MEETING:	PLAN COMMISSION
DATE AND TIME:	MONDAY, SEPTEMBER 14, 2020 6:30 p.m.
LOCATION:	Germantown Village Hall Board Room N112 W17001 Mequon Road

- B. MSI General, Agent for Moldmakers Leasing & Investments LLP, Property Owner and MGS Manufacturing Group Inc.- W190 N11701 Moldmakers Way. Site Plan Review for a 121,191 SF Industrial Building Addition and a Certified Survey Map (CSM) Lot Combination & Street/ROW Vacation Request. **[ACTION]**

MSI General Corp. / The Sigma Group Inc. / MGS Mfg. Group Inc.
Village Planner Report *Germantown, Wisconsin*

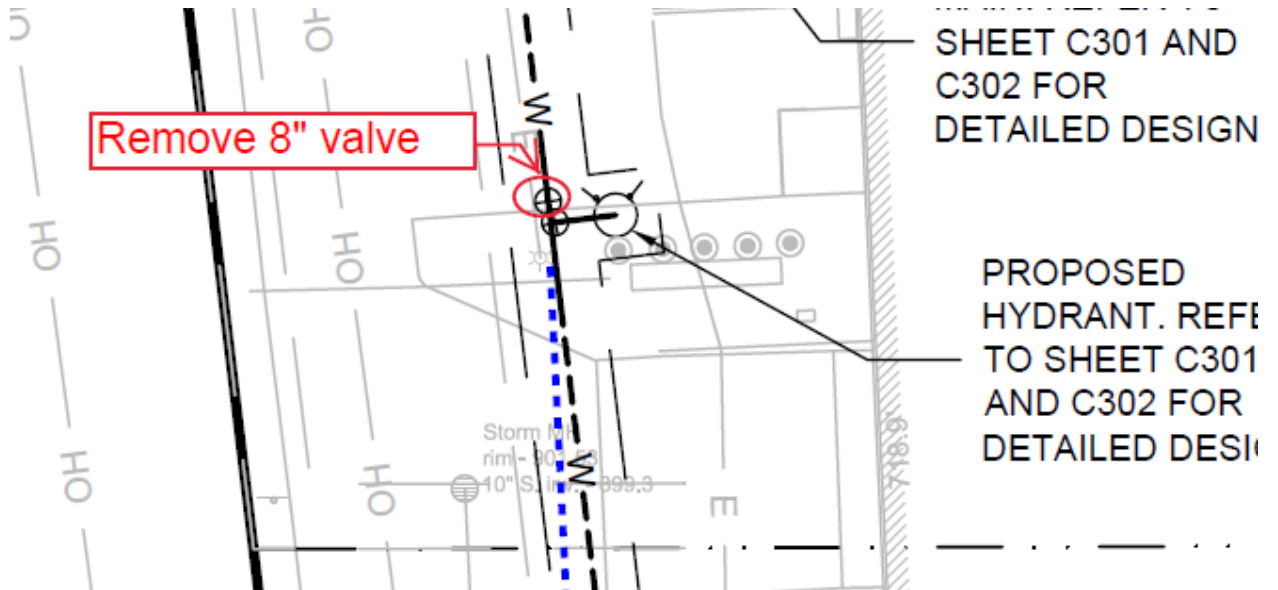
1. Corrections to sheet C300-Remove (2) valves per pdf mark ups

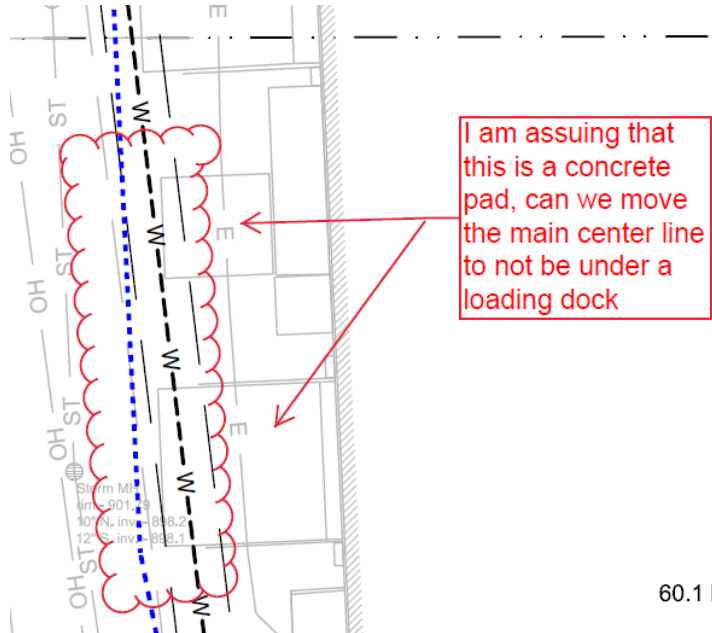
2. Relocate center line of main outside of concrete loading area-if possible.

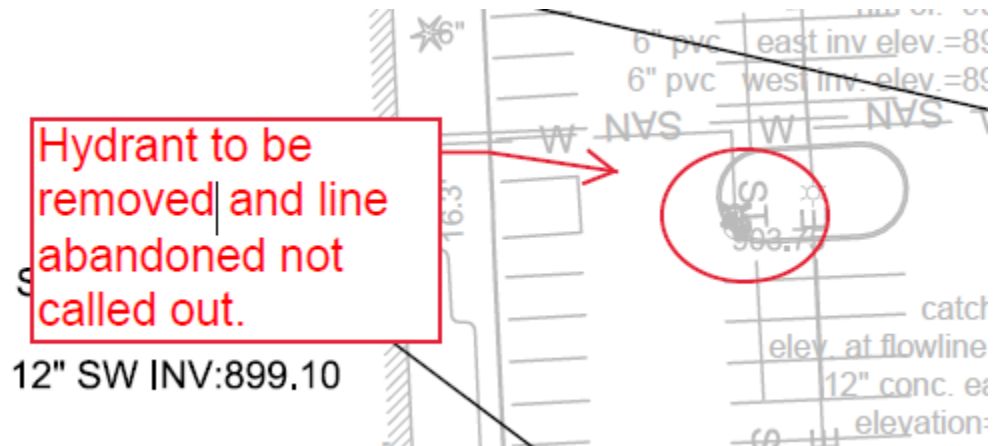
4. Hydrant and water main not called out on plan (from last review)

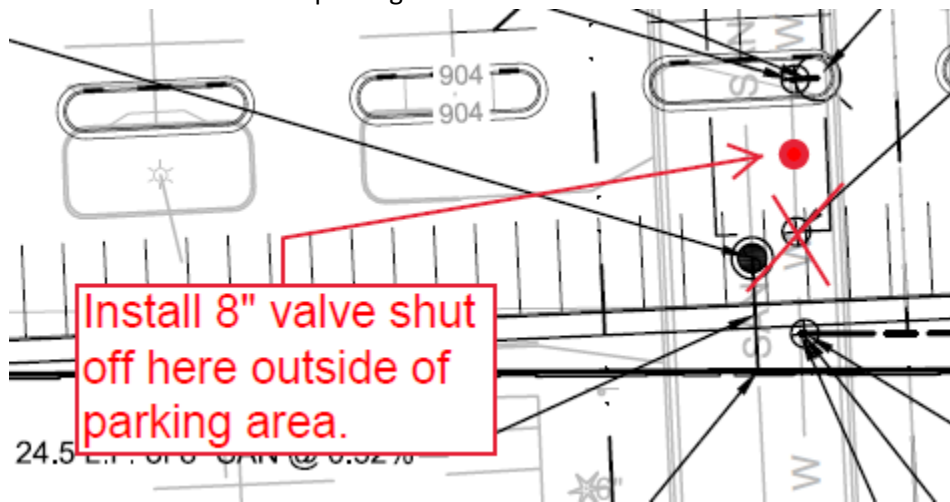
5. Relocate valve outside of parking area.

C401 Site Details

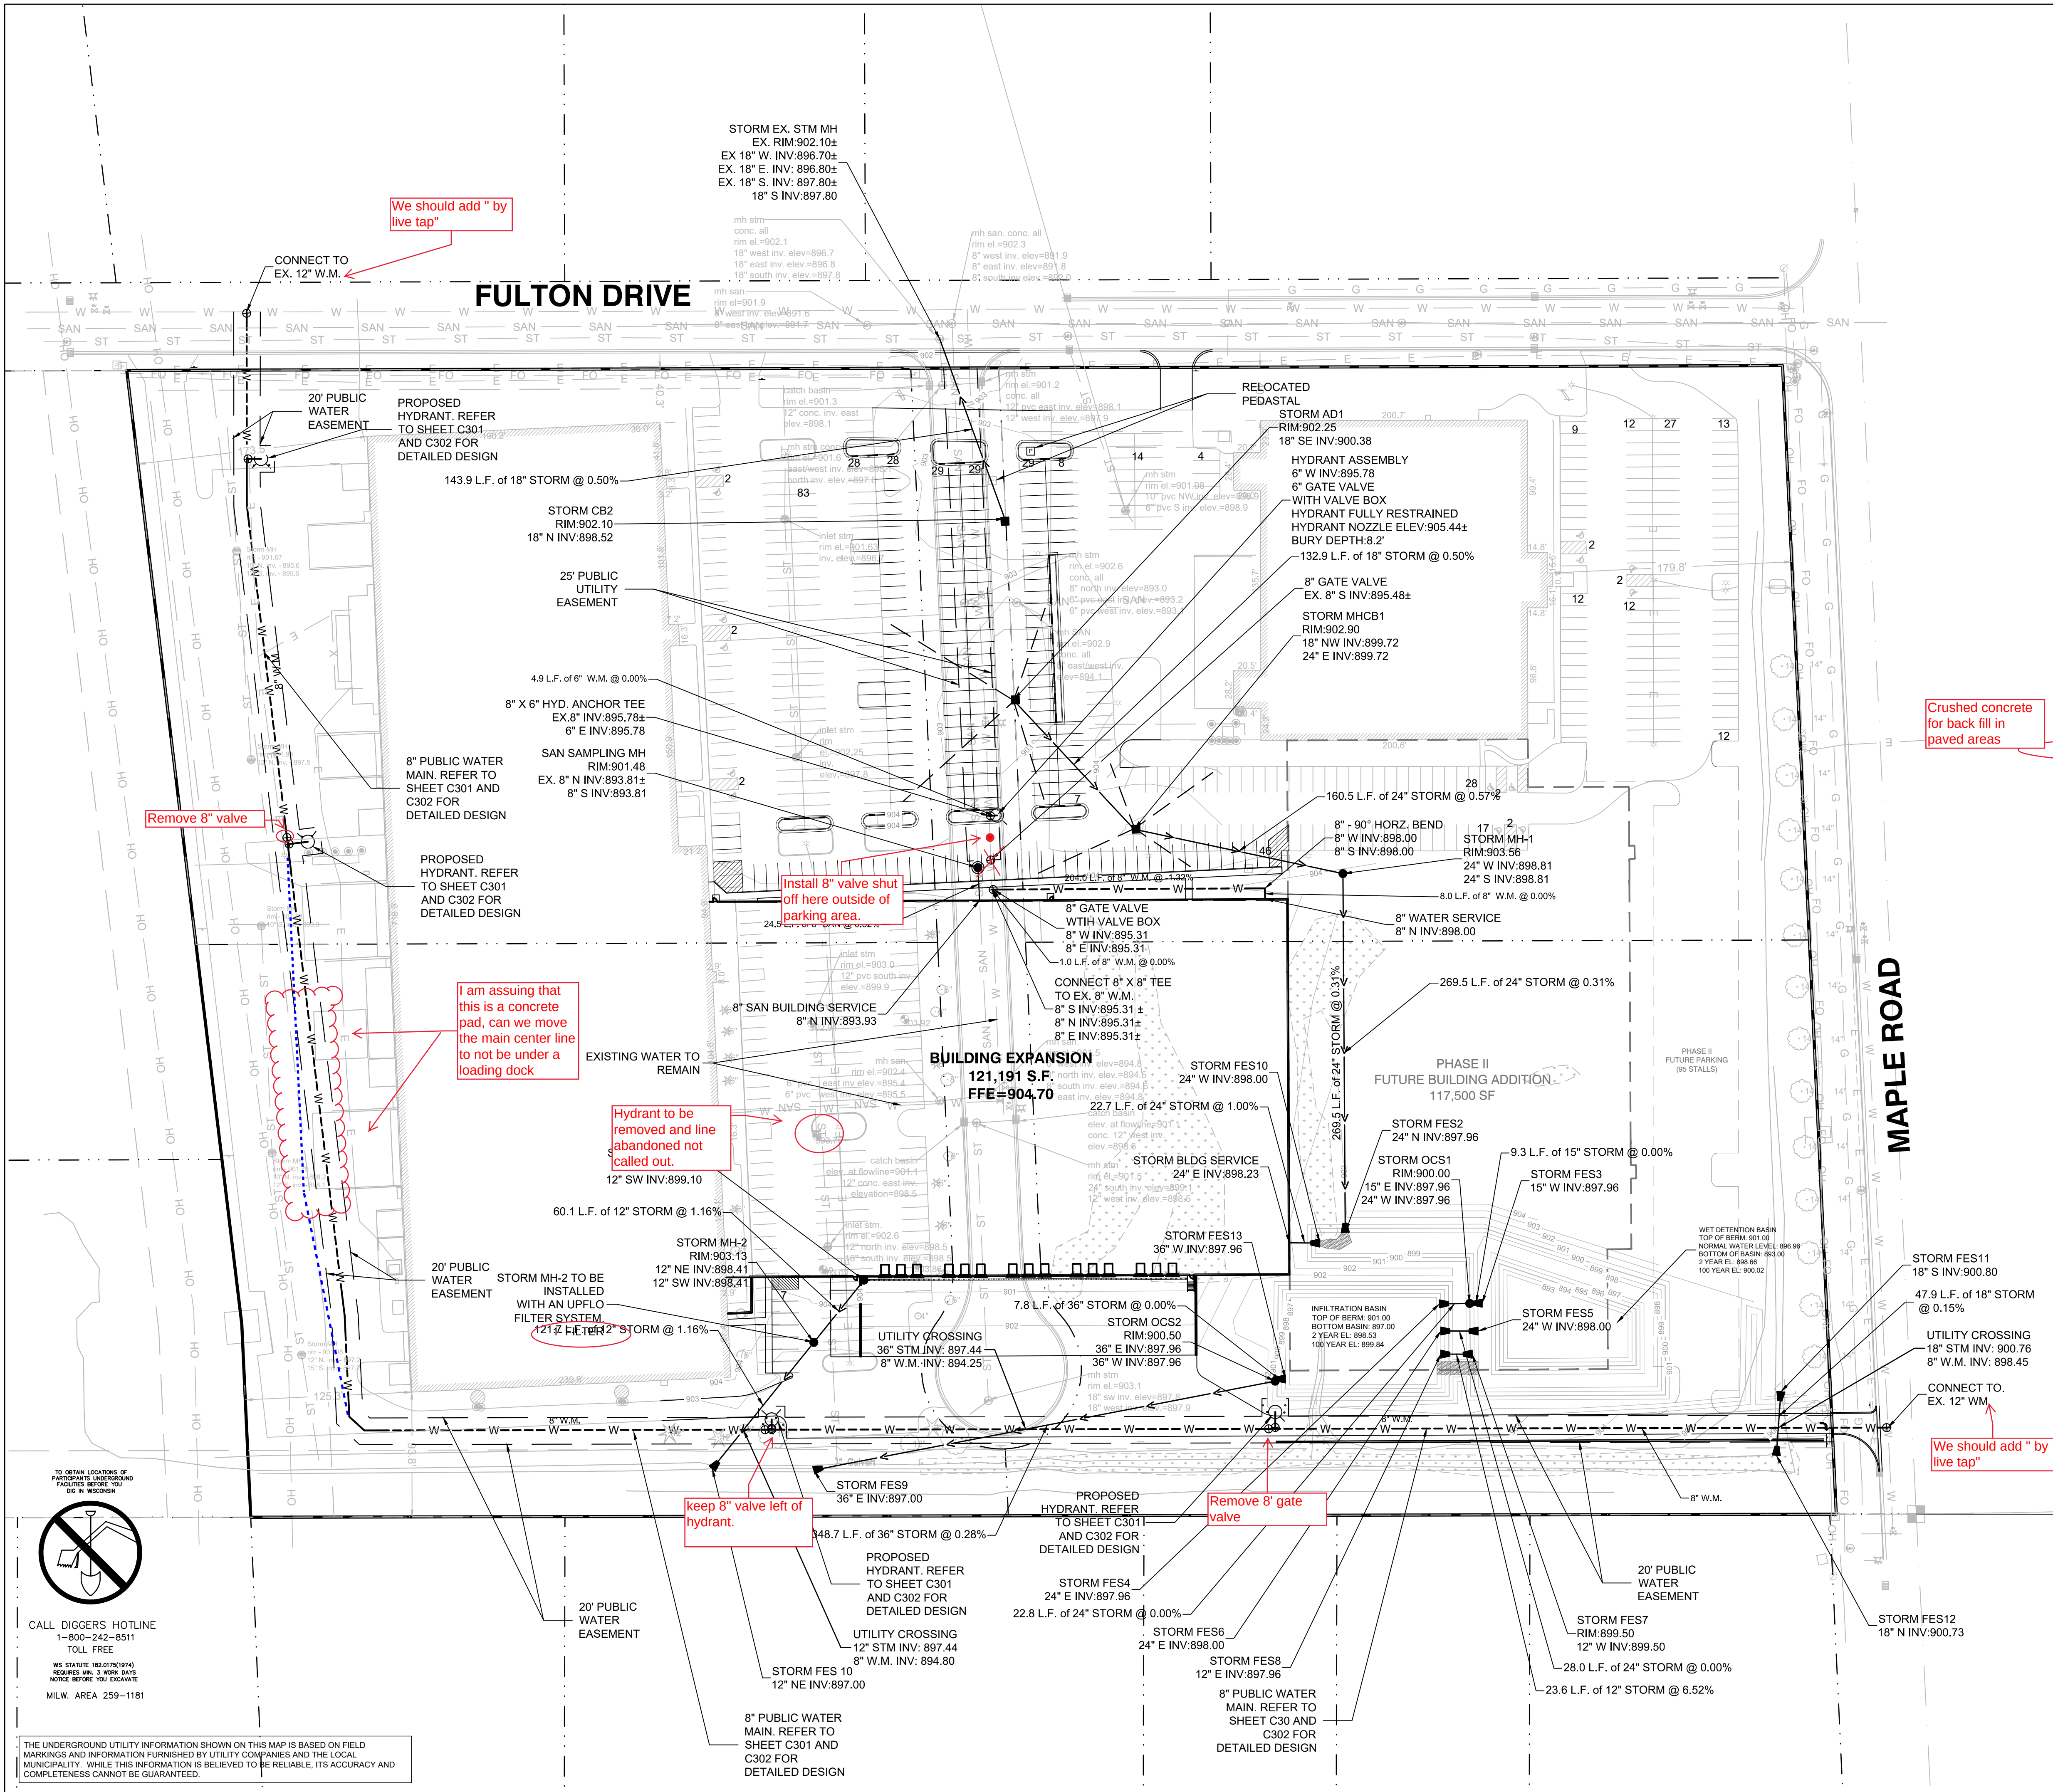
1. *Driveway detail does not match what is proposed on the plans. Revise detail to match plans.*
2. *Pavement details don't show any layer thicknesses.*
3. Upflow filter detail calls for outlet pipe diameters of 10", 12" or 15". Plans show a 24" outlet pipe. Provide information showing this filter can accommodate a 24" outlet pipe and the associated flow. **Dimensions shown on the detail do not match elevations shown on the plan.**
